## SERVICE INFORMATION NO. SI 20E-007

Rotax Service Bulletin No. SB-912i-009 Replacement of oil filter

# Replacement of oil filter for ROTAX® Engine Type 912 i, 912 and 914 (Series)

Fig. 1  
Oil filter

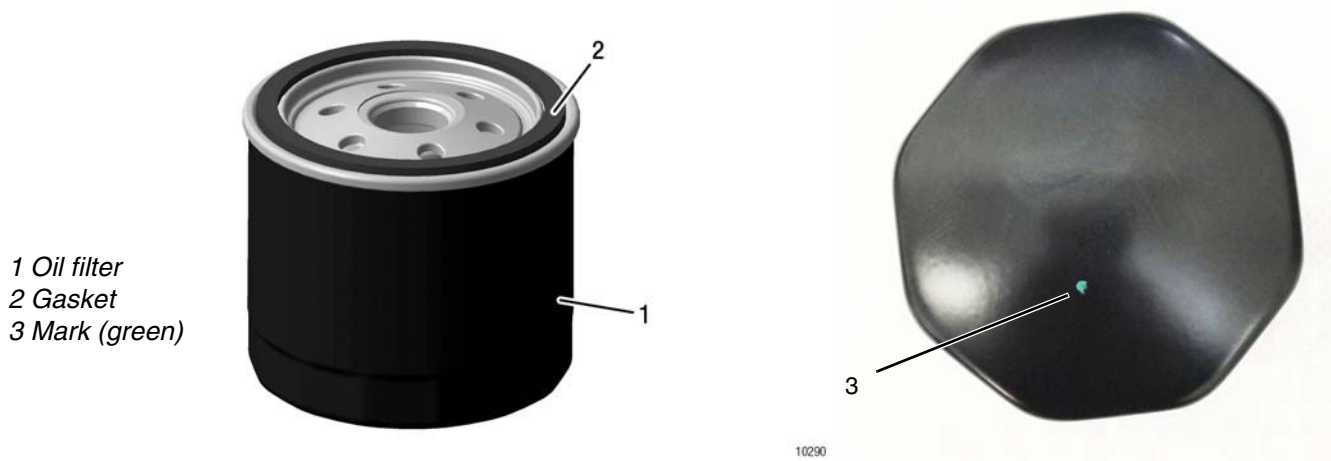
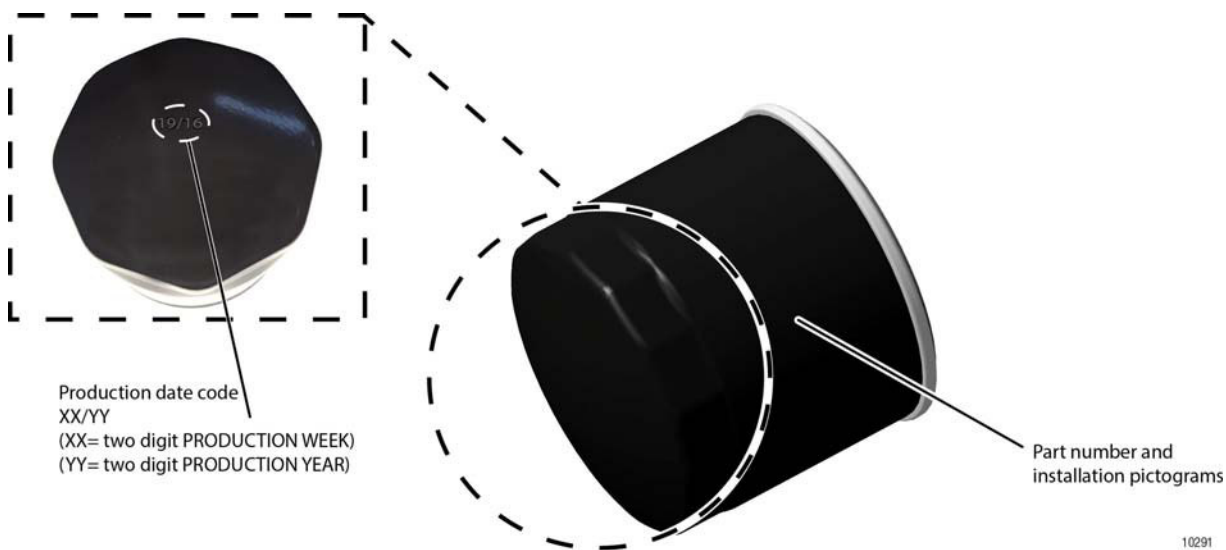
The above engines have been fitted by the manufacturer with an oil filter part no. 825016 with a production date code 10/17 up to 38/17 and have no green mark see Fig. 1).

All engines are affected, which have been equipped with an oil filter part no. 825016 (with a production date code from 10/17 up to 38/17) during engine repair, maintenance or general overhaul as of June 8<sup>th</sup>, 2017 to October 31<sup>st</sup>, 2017 and have no green mark. see Fig. 1).

Step	Procedure
1	Check the engine logbook and maintenance documentation or shipping documents to see if this Service Bulletin has already been accomplished.
2	<p>Check whether the affected oil filter shows a green mark on the crown of oil filter (as illustrated in Fig. 1) (same area as production date code).</p> <ul style="list-style-type: none"> <li>- green mark is present: this oil filter is OK as it has already been tested by the supplier and can be used even though the production date code is from 10/17 to 38/17. No further actions are required.</li> <li>- green mark NOT present: this oil filter is NOT OK, please follow the instructions in section 3.2).</li> </ul> <p>NOTE: If production date code is not easy to read, use a proper means of light (e.g. flashlight directed at a proper angle onto the oil filter crown etc.) for better visibility of the coding imprint.</p>

Step	Procedure
1	Remove the affected oil filter according to the Maintenance Manual Line.
2	Install the new oil filter according to the Maintenance Manual Line.
